## ADDENDUM NO. 1

Roof Replacement  
Kirksville Regional Office  
Kirksville, Missouri  
PROJECT NO.: M1706-01

ROOF  
REPLACEMENT

KIRKSVILLE REGIONAL OFFICE

**DOWNSPOUT TIE-IN TO STORM**  
SCALE: N.T.S.

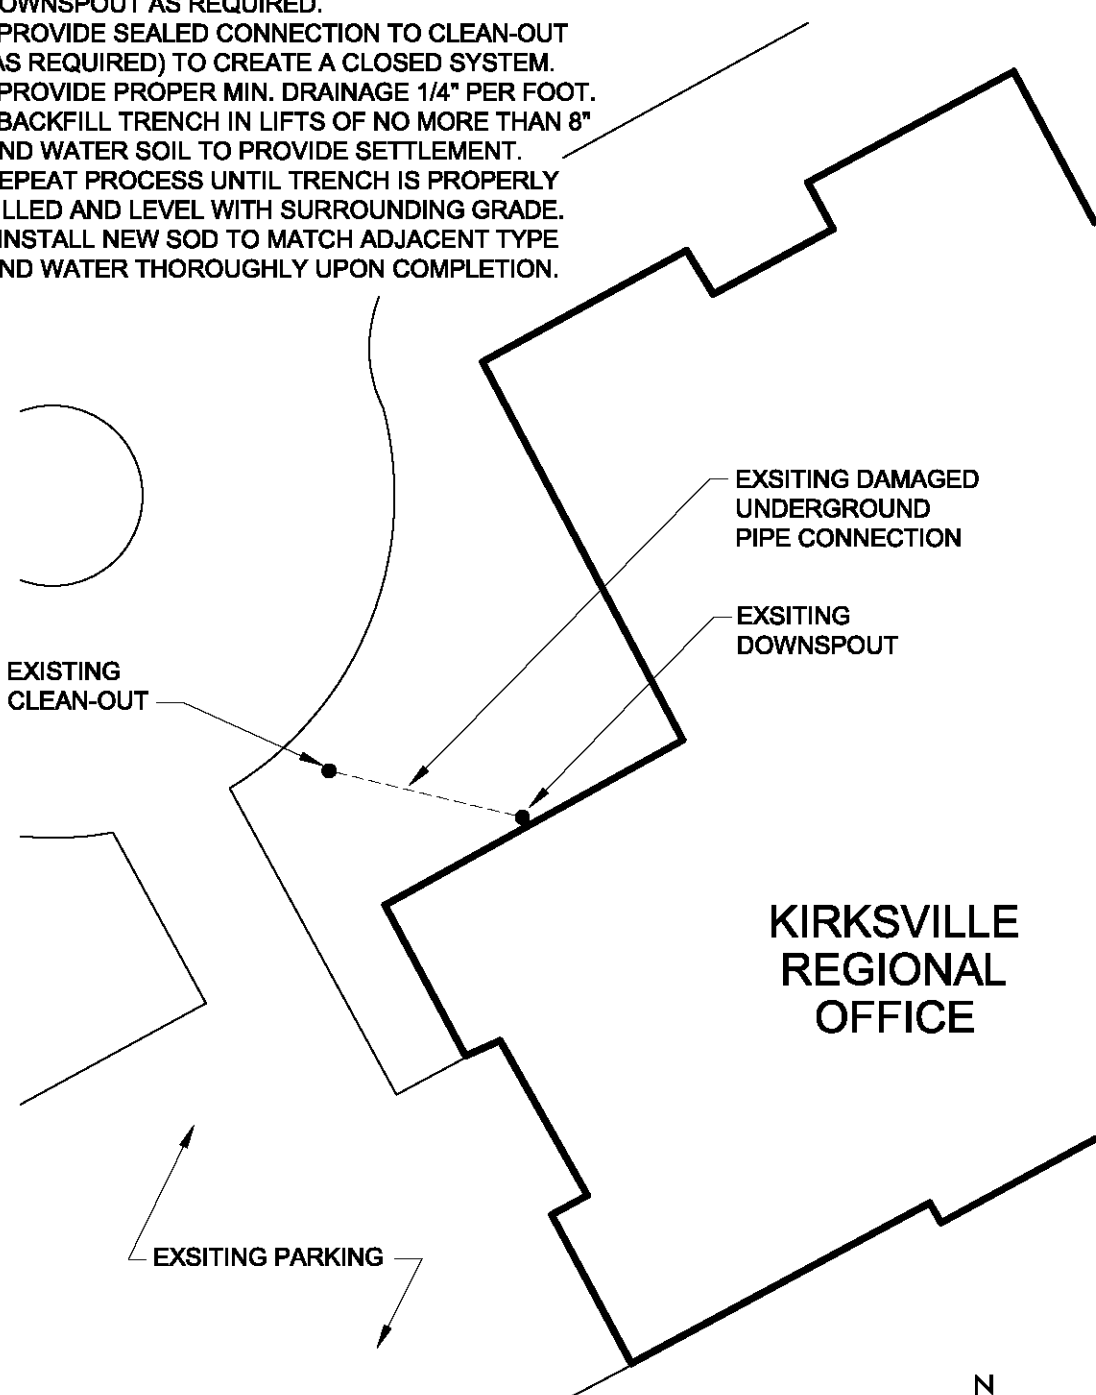
- 1. Drawing A-503; ROOF DETAILS
  - a. **ADD** Detail 5-Downspout Tie-In To Storm on attached Supplemental Sketch SK-1. Replace existing clay pipe from downspout to storm cleanout with 4” PVC pipe.

- EXCAVATE DAMAGED PIPE AND DISCONNECT FROM DOWNSPOUT AND CLEAN-OUT.
- HAUL OFF AND DISPOSE OF MATERIALS (EXCEPT FOR SOIL) OFF-SITE TO AN APPROVED FACILITY.
- PREPARE DOWNSPOUT AND CLEAN-OUT FOR NEW UNDERGROUND PIPE CONNECTION.
- INSTALL NEW 4" PVC UNDERGROUND CONNECTION AND ATTACH TO DOWNSPOUT AND CLEAN-OUT.
- PROVIDE GRAVEL FOR PROPER PIPE BASE.
- PROVIDE NEW CONNECTION BOOT TO DOWNSPOUT AS REQUIRED.
- PROVIDE SEALED CONNECTION TO CLEAN-OUT (AS REQUIRED) TO CREATE A CLOSED SYSTEM.
- PROVIDE PROPER MIN. DRAINAGE 1/4" PER FOOT.
- BACKFILL TRENCH IN LIFTS OF NO MORE THAN 8" AND WATER SOIL TO PROVIDE SETTLEMENT. REPEAT PROCESS UNTIL TRENCH IS PROPERLY FILLED AND LEVEL WITH SURROUNDING GRADE.
- INSTALL NEW SOD TO MATCH ADJACENT TYPE AND WATER THOROUGHLY UPON COMPLETION.
